Wisconsin Department of Transportation

Proposal #01: ID 1005-10-81, WISC 2018 135
Illinois State Line – Madison
Kennedy Road To Knutson Road
IH 39
Rock County

This is Addendum No. 01, which provides for the following:

ADDENDUM NO. 01

Addendum No. 01
ID 1005-10-81
Revised Sheet 9
March 5, 2018

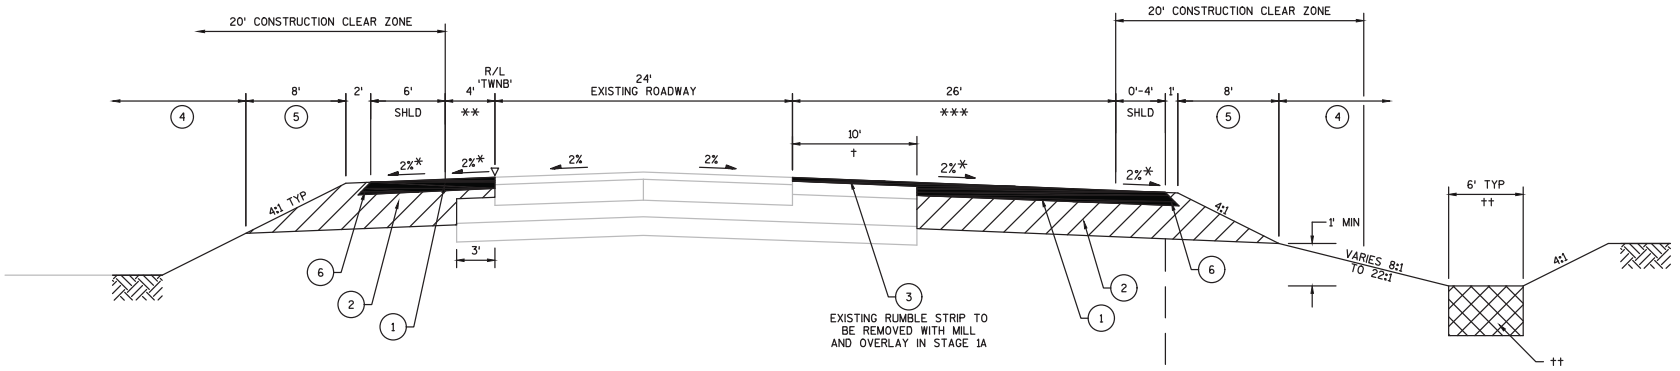
Revised Plan Sheets	
Plan Sheet	Plan Sheet Title (brief description of changes to sheet)
3, 8-15, 20-21, 23, 53, 55-62, 204-205, 376-378, 381, 397, 401, 424, 444	HMA pavement type switched from 460.7624 to 460.7424. Updated notes and labels on all sheets.
46	Updated to show Removing Concrete Barrier.
202	Added Removing Concrete Barrier table to sheet.
212, 214	Updated crash cushion notes.
245-248	Updated profile information.
452-453, 455, 468, 471, 475-476, 490, 494-496, 500-505,	Corrected existing and added missing section labels.
543-555, 557	Updated cross sections based on new profile information.
